219609.01
15 June 2026
R.006.Rev0
DIH:jl

Response to Remediation SSDA Comments Proposed Warehouse Development 49-61 Stephen Road, Banksmeadow

The following provides responses by Douglas Partners Pty Ltd (DP), in consultation with ESR Australia Pty Ltd (ESR), to the additional information sought by the Department of Planning, Housing and Infrastructure (DPHI), DPHI (2026)¹. This is with respect to the State Significant Development Application (SSD-65924461) and the associated proposed warehouse development at 49-61 Stephen Road, Banksmeadow.

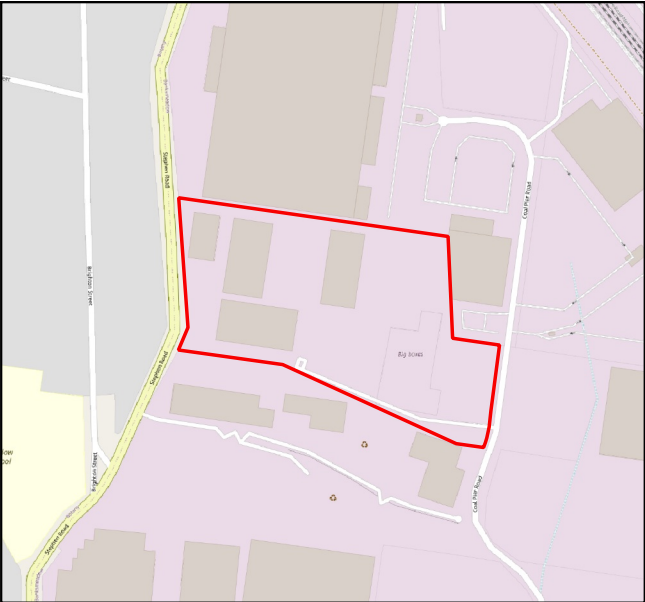
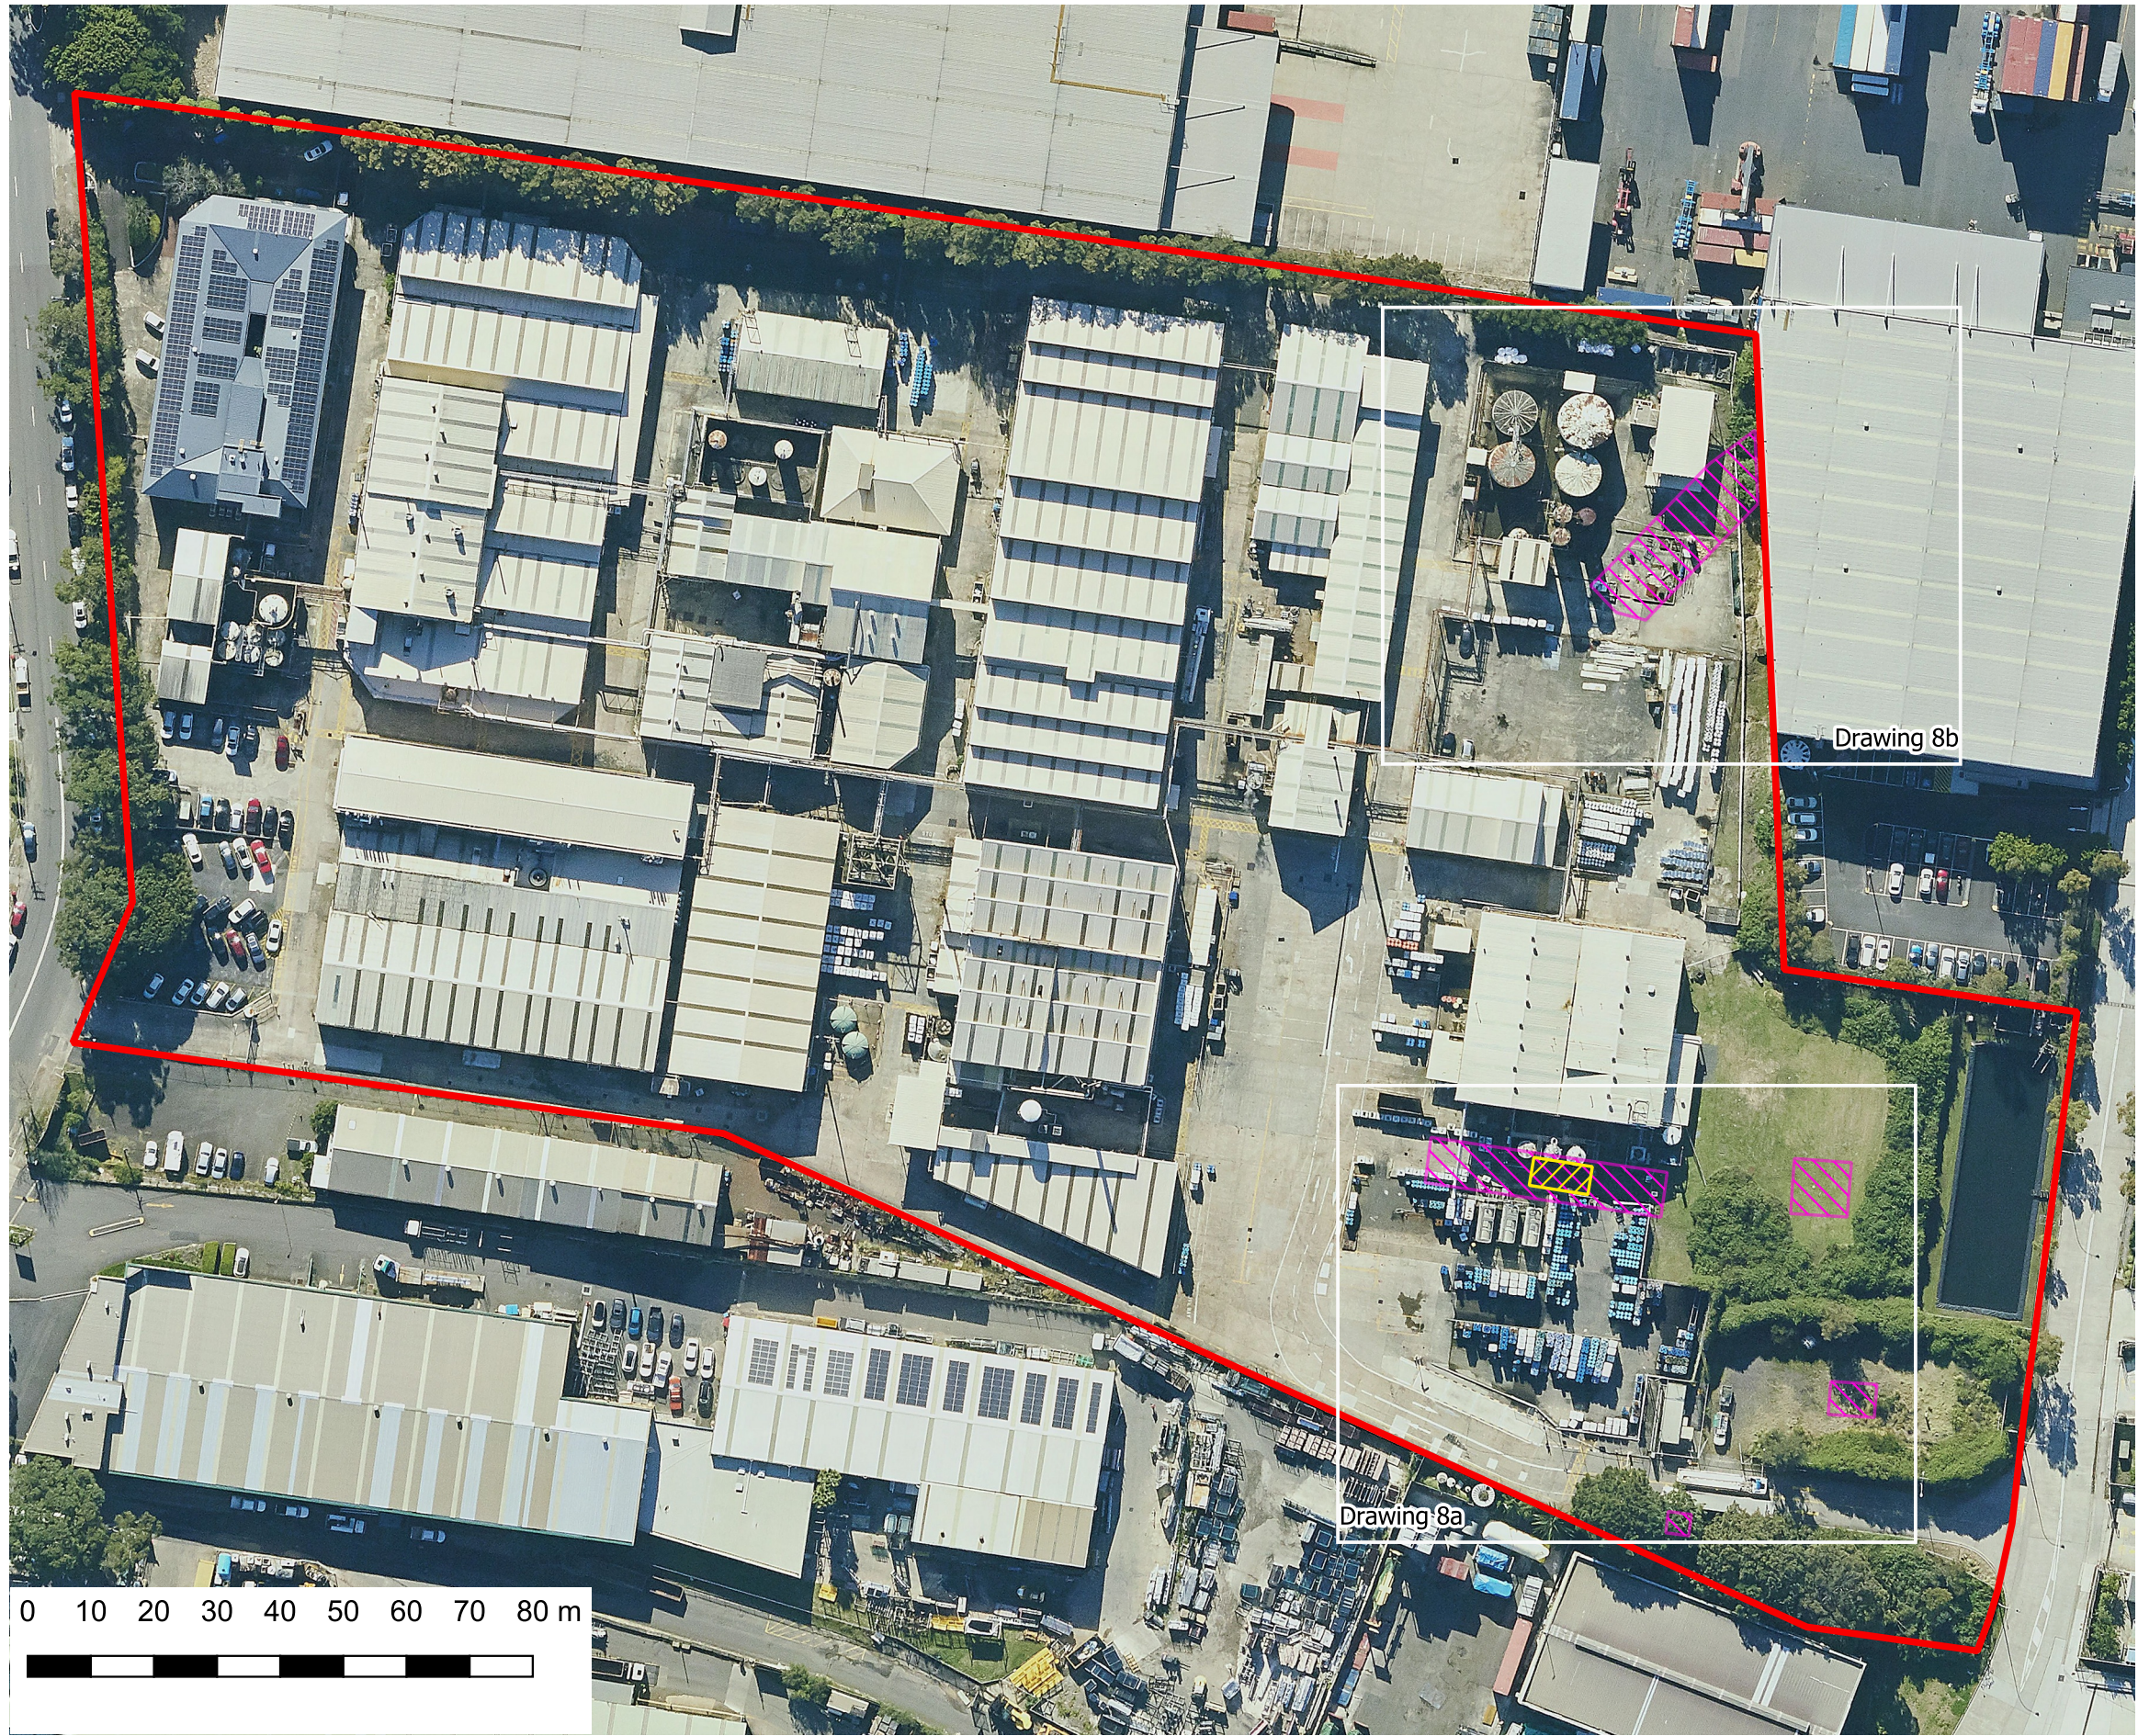
The Remedial Action Plan (RAP) proposes placing soils containing organochlorine pesticide concentrations exceeding the remediation criteria within a containment cell. Additional information is required to clearly define the location and design of the proposed containment cell, its relationship to the overall development, and to provide written interim advice from the Site Auditor confirming acceptance of this approach.

Area 6 is shown on Drawings 7 and 9, Appendix A1 of the RAP (also attached).
 - o Contingency in the order of 20% (or ~500 m³). Moreover, contingency has also been incorporated into the approach by distinguishing between the material required to be placed in the cell and that recommended to be placed in the cell (discussed further in Section 3 below and in Section 10.2 of the RAP).
